**GLYNN COUNTY STADIUM
SITE WORK**

ADDENDUM NO. 3

DATE: May 1, 2018

GLYNN COUNTY FIELDHOUSE ADDITION
SANITARY SEWER CLARIFICATION

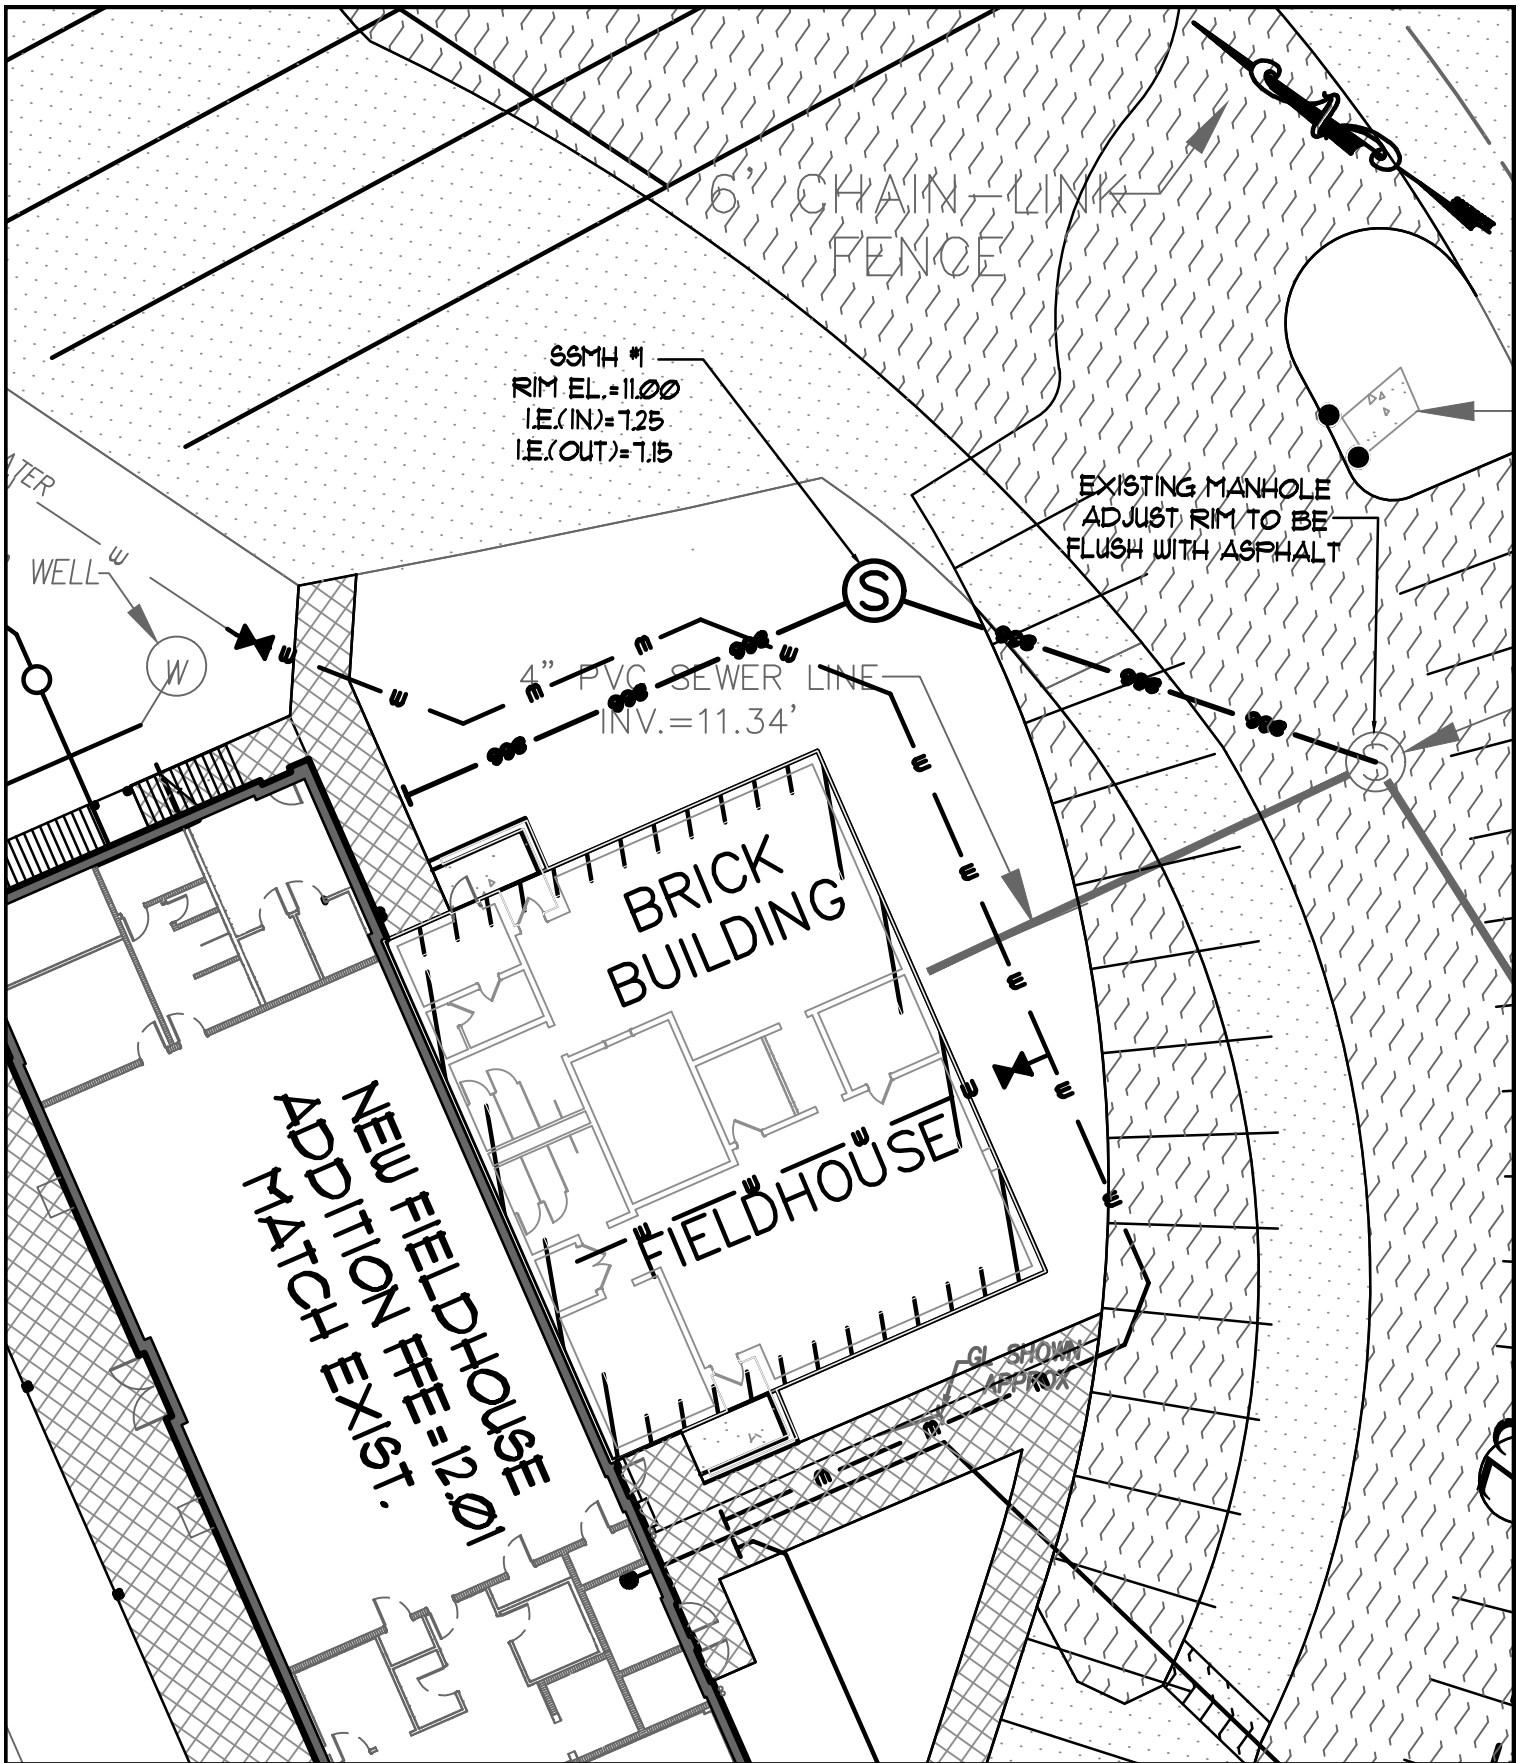
- A. Attached “Sketch – Sanitary Sewer Clarification” dated 4/26/18 is part of Sheet C4.1 showing rim elevation for the new sanitary sewer manhole.
